# Access Compliance Report

## Public Rights-of-Way

### (Curb Ramps)

Intersection ID: 12411	Main Street: GREENLAND_AV	Cross Street: W_MOREHEAD_ST	Location: NW
ADA ID: 77885640A203	Ramp Type: PerpDiag	Initial Pass/Fail: Fail	Overall Compliance: No
Severity Score: 10			
Codes/Mitigation Info/Possible Solution		Field Measurements/Component Compliance

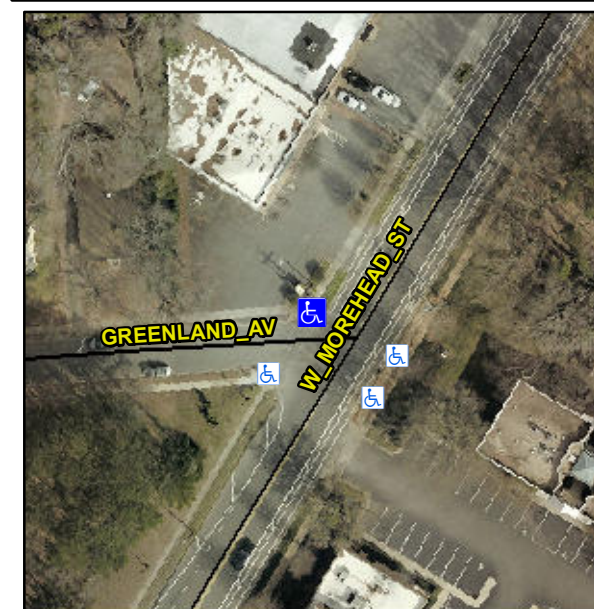
**R304.5.1, R304.5.3**

Compliance	Description	Data	Compliance	Description	Data
N/A	Ramp Length (in)	78.0	Yes	Ramp Slope (%)	5.0
No	Ramp Width (in)	47.0	No	Ramp XSlope (%)	2.9
N/A	Flare Type LT	N/A	N/A	Flare Type RT	N/A
N/A	Flare Slope LT (%)	N/A	N/A	Flare Slope RT (%)	N/A
N/A	Flare Traversable LT?	N/A	N/A	Flare Traversable RT?	N/A
N/A	Landing Length (in)	N/A	N/A	DWS Provided?	N/A
N/A	Landing Width (in)	N/A	N/A	DWS Contrast?	N/A
N/A	Landing Slope (%)	N/A	N/A	DWS Length (in)	N/A
N/A	Landing X Slope (%)	N/A	N/A	DWS Full Width?	N/A
N/A	Landing Curb? (Y/N)	N/A	N/A	DWS Offset (in)	N/A
N/A	Shared Landing?	N/A			
N/A	Gutter Ponding?	N/A	N/A	Gutter Slope (%)	N/A
N/A	Gutter Lip Ht (in)	N/A	N/A	Gutter X Slope (%)	N/A
N/A	Painted X Walk1?	No	N/A	Painted X Walk2?	No
	X Walk 1 Direction	To SW		X Walk 2 Direction	To SE
N/A	X Walk 1 Width (in)	N/A	N/A	X Walk 2 Width (in)	N/A
	X Walk 1 Slope (%)	2.8		X Walk 2 Slope (%)	2.6
	X Walk 1 X Slope (%)	0.1		X Walk 2 X Slope (%)	2.3

**Remove & Replace Curb Ramp With Two New Directional Ramps or Equivalent.**
